# AGENDA

For the Council Meeting to be Held  
At the Saanich Municipal Hall  
770 Vernon Avenue  
**MONDAY, JANUARY 11, 2016**

**To:** Terence Radford, BFA, MLA; Murdoch de Greeff Inc.  
**From:** Tracy Motyer, R.B.Tech, Biology Technologist  
**Date:** October 5, 2015  
**Re:** **3777 Waring Place – Landscape Plan Comments**  
**File:** Working Files:Projects (server):3777 Waring Place:Drawing Comments 151001:3777WaringPlace LandscapePlanReview 151001.docx

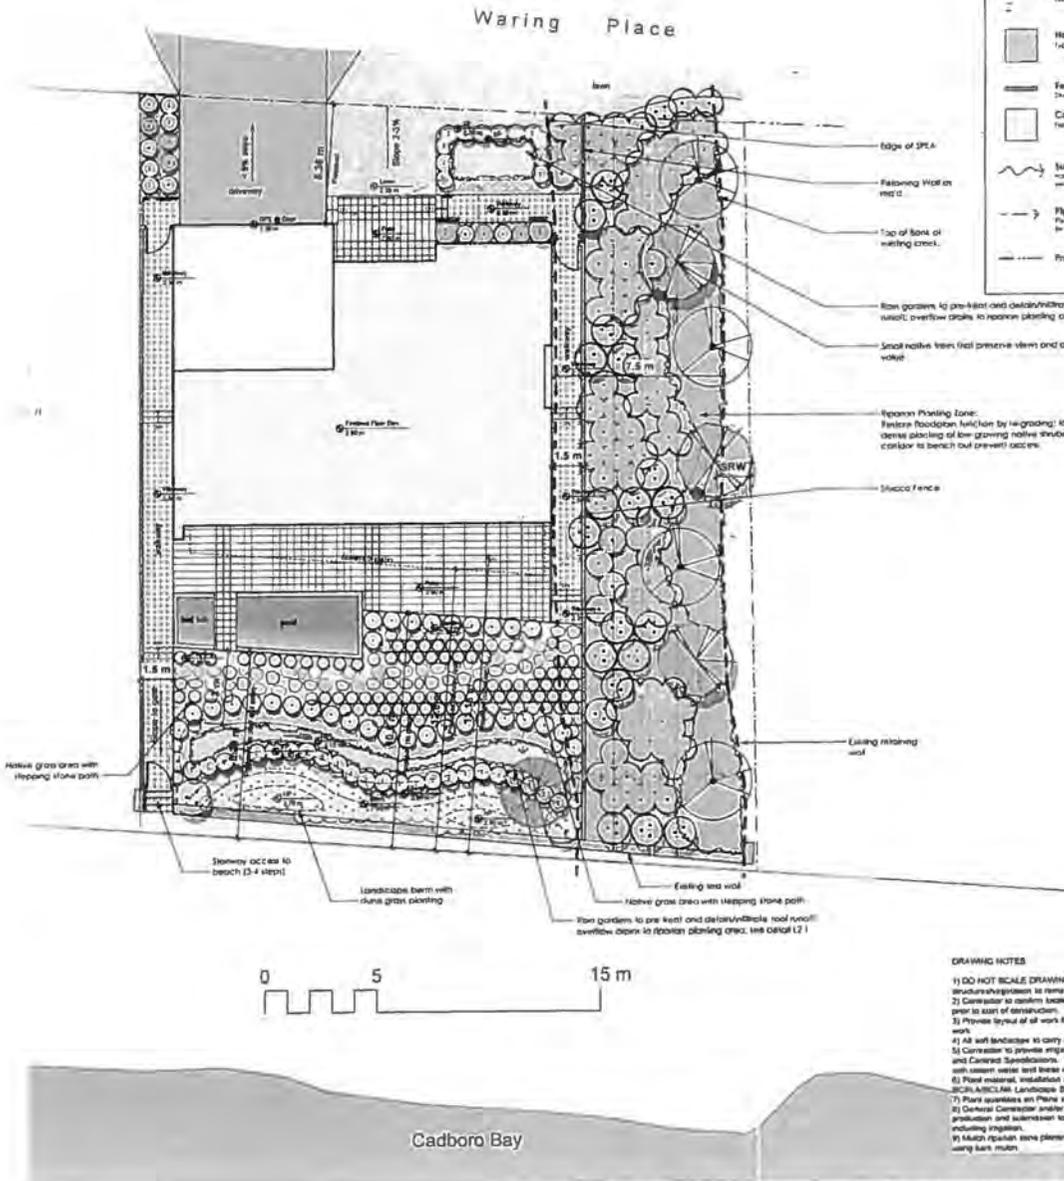
Only native riparian plant species should be planted between Hobbs Creek and the stucco fence line identified in the preliminary landscape plan prepared by Murdoch de Greef. The species listed on the landscape plan include riparian plants suitable for planting on the newly created floodplain terrace - *Carex lyngbeii*, *Carex obnupta*, *Spiraea douglasii*, and *Oenanthe sarmentosa*. Given the recommendation to not re-grade the streambank, for the purposes of invasive plant management, these species should be reassigned with other native species capable of withstanding drier site conditions. Permanent irrigation should be installed for this area to ensure the successful growth of these plants.

Lastly, *Rosa rugosa* is becoming recognized as an alien species that can outcompete native vegetation on dunes and ocean shoreline areas. Given the presence of the beach shoreline immediately adjacent to 3777 Waring Place *Rosa rugosa* **should not** be planted on this site (Weidema, 2006).

There was no detail provided for the rain garden overflows. The rain garden overflow must not be allowed to channelize as this may cause erosion of the Hobbs Creek streambank. The drainage pathway/discharge location may need to be armored to prevent erosion. Alternatively, flows out of the rain gardens could be dispersed as sheet flow through the riparian area.
